From: Nedland, Thomas S - DNR [Thomas.Nedland@wisconsin.gov]
Sent: 1/28/2021 8:40:13 PM
To: 'eric.m.norton@usace.army.mil' [eric.m.norton@usace.army.mil]; Pelloso, Elizabeth [Pelloso.Elizabeth@epa.gov]; Weaver, Kerryann [weaver.kerryann@epa.gov]
Subject: FW: Help - Quick Review?

I just IM'd you, but wanted to follow up with an email. Attached is the pdf I mentioned in the IM. Item 4 on page 3 is where we could use your help. Our big question is whether you think it is appropriate to use the Theis Method to calculate a drawdown, if there was not necessarily field data used to populate the parameters (used well log and reported pumping rate info instead).

Figure B16. Theis drawdown prediction for the on-site irrigation well for existing conditions at a distance of 500 ft (0.38 ft at end of 4-month growing season).

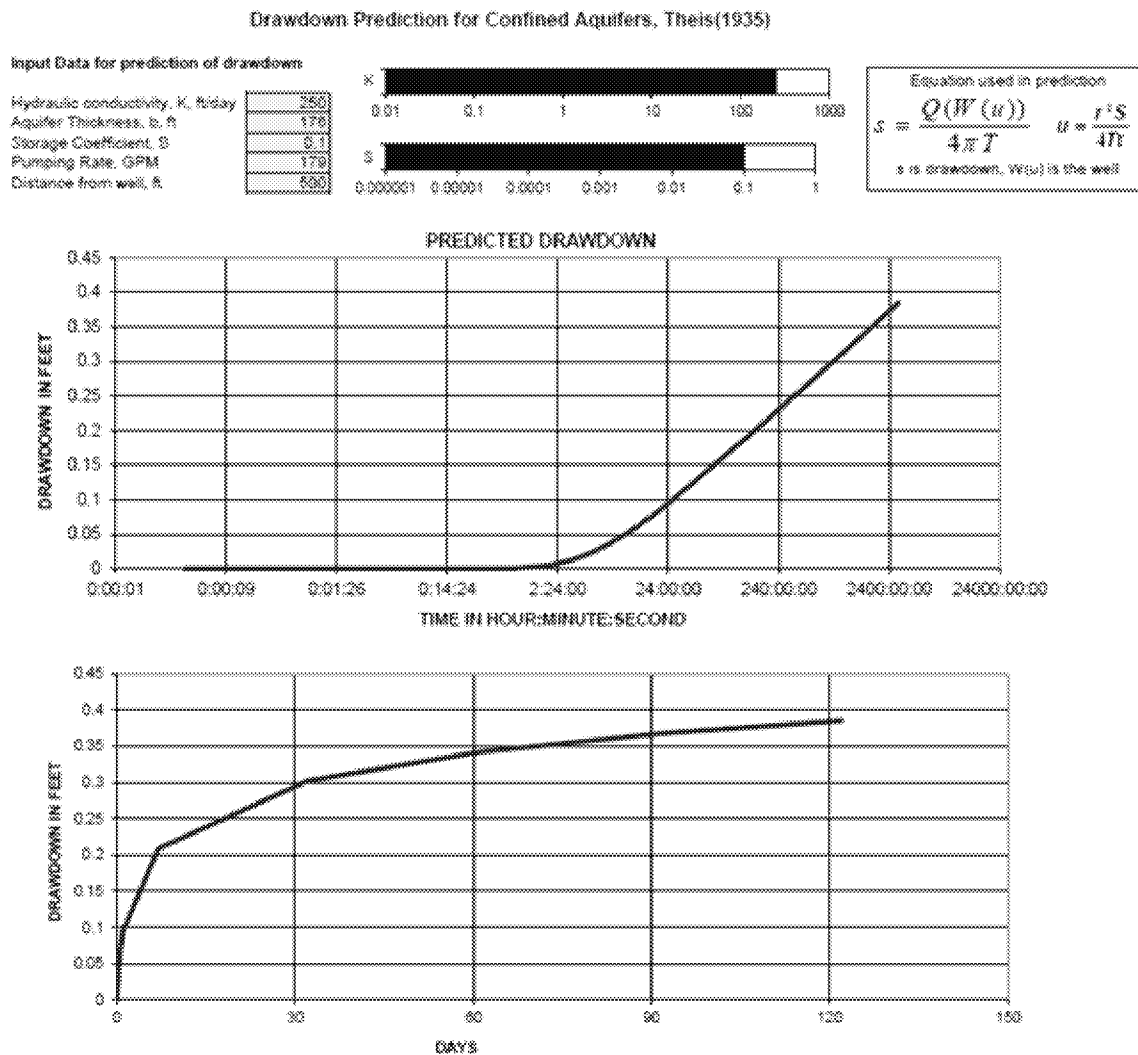
Sorry about the delayed response. Their calculations are correct. The parameters seem within the reasonable range for a sand and gravel aquifer. With better location information we might be able to improve on them. The 250 ft/d hydraulic

conductivity is very high but that's not uncommon in a sand and gravel aquifer. I'm not sure how that fits with a wetland only 500 ft away though. At 100 ft/d the drawdown at 500 ft would double.

Also, the use of an average pumping rate is not protective. If we were doing the analysis for a new high-capacity well (and we still considered wetlands in our review process) we'd use a higher pumping rate which would produce more drawdown. In a dry summer, when recharge approaches zero (like Theis assumes), and pumping is at its highest, water use can be much higher than average. This is also the time when water resources and their biota are most sensitive. So we typically start our reviews using pump capacity as the pumping rate and work our way down to more realistic scenarios. For a more protective analysis we could simply multiply the pumping rate by a safety factor, like 4. So using their analysis at 176 gpm (for the well irrigating the whole field) would be worst-case look at annual impacts from irrigating ¼ of that field.

Figure B17. Theis drawdown prediction for the on-site irrigation well for proposed conditions at a distance of 500 ft (0.1 ft at end of 4-month growing season).

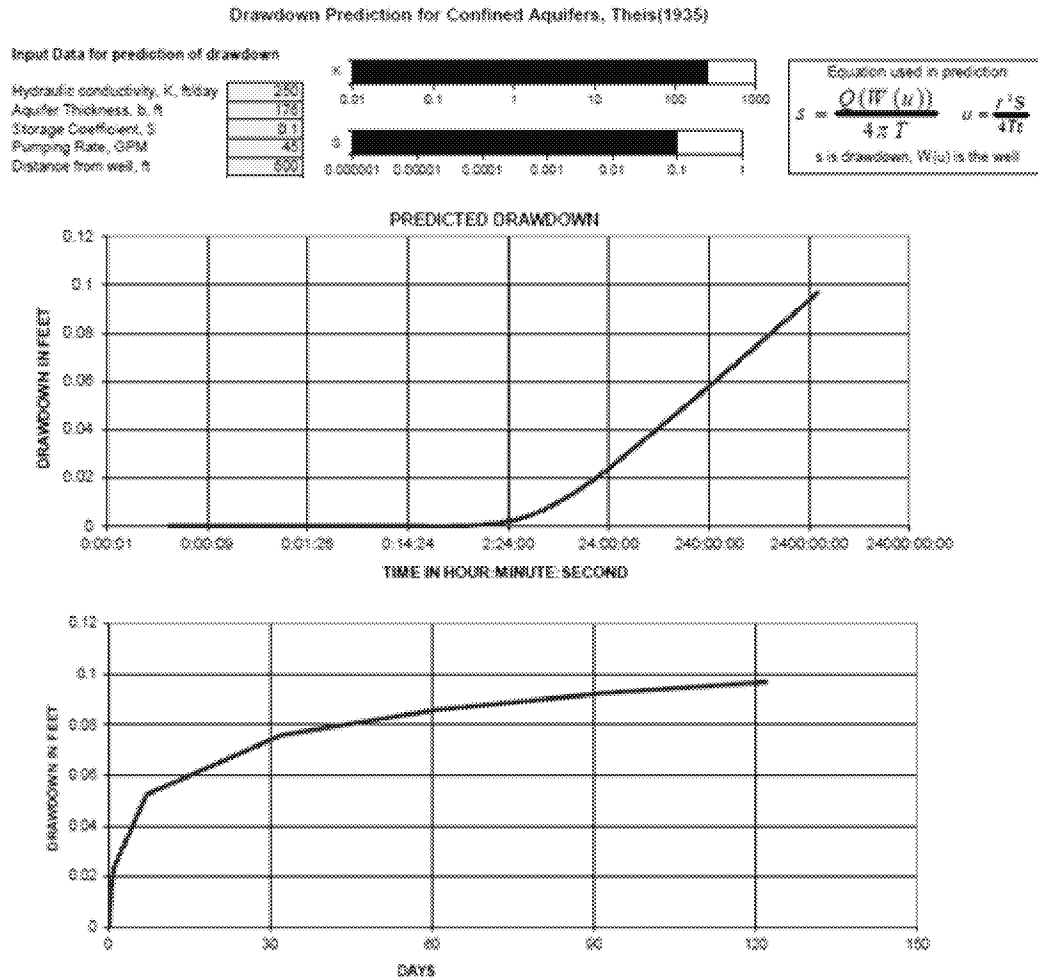
I should re-explain some things. The hydraulic conductivity is not the same thing as distance from the well. Hydraulic conductivity is a measure of how easily water can pass through the aquifer. Reducing the distance from the pumping well to the wetland is a different thing entirely. That said, your 2nd bullet point is correct, if only by accident. Using their parameters, if the well is only 100 feet away the drawdown increases from 0.37 to 0.57 in the 176 gpm pumping scenario. But I'm not going to hang my hat on that because the parameters look off.

I did the analysis assuming that the site is somewhere near Big Hollow Road, which I found on the map. Five well logs in the areas show consistent specific capacities of around 20 gpm/ft. This can be converted to transmissivity and the resulting analysis is a lot different than if you use the K=250 ft/d and 179 ft thickness used by the consultant.

- If the well pumps at 176 gpm for 120 days, drawdown at 500 feet from the well would be approximately 2.6 feet
- If the well pumps at 45 gpm for 120 days, drawdown at 500 feet from the well would be approximately 0.64 feet
- If the well pumps at 176 gpm for 120 days, drawdown at 100 feet from the well would be approximately 4.6 feet
- If the well pumps at 45 gpm for 120 days, drawdown at 100 feet from the well would be approximately 1.2 feet

Keep in mind that these estimates assume zero recharge.

Also just looking for your general knowledge/opinion – Do you expect that a high capacity well near Spring Green would only generate a 0.1 foot drawdown within 500 feet? I know there are a lot of variables to consider, but just looking for a gut reaction.
